PROJECT
Multiple Residential
Lot 8002 Baringa Drive, Aura QLD

PLANS AND DOCUMENTS referred to in the PDA DEVELOPMENT APPROVAL

Approval no: DEV-2026-CAS-4784

8002 MULTIPLE RES. - GROUND FLOOR

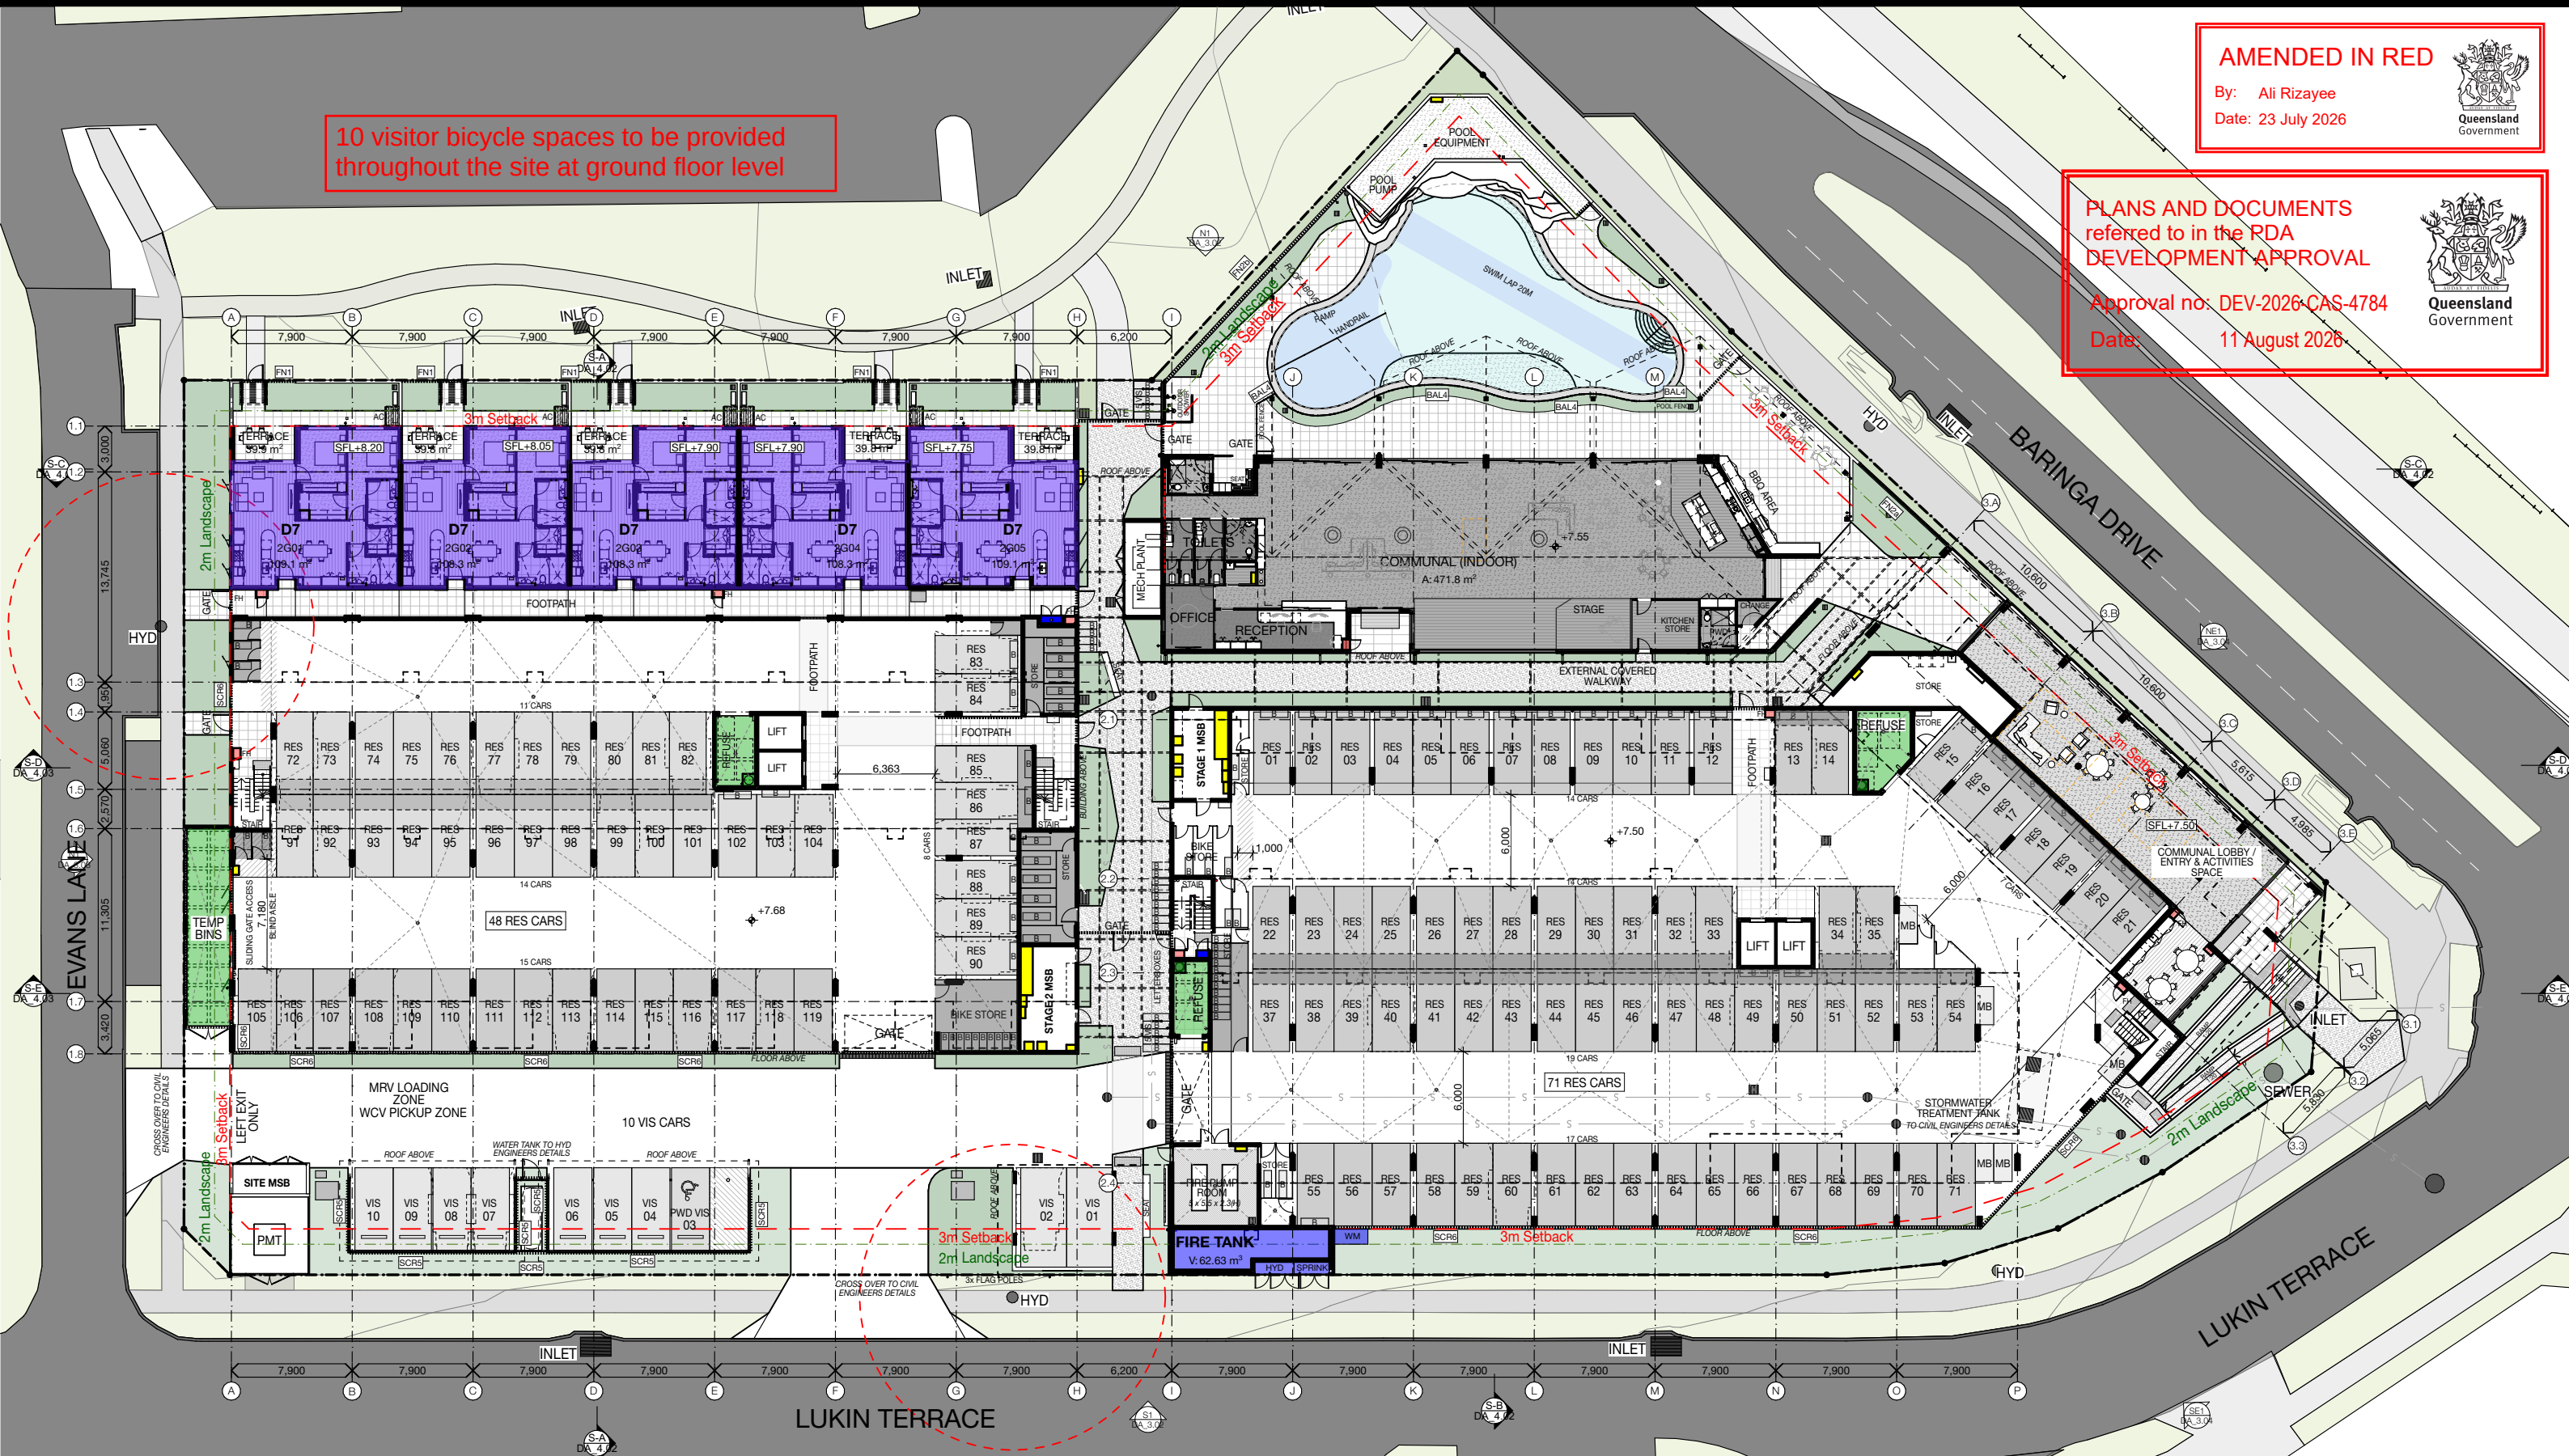
AMENDED IN RED

10 visitor bicycle spaces to be provided
throughout the site at ground floor level
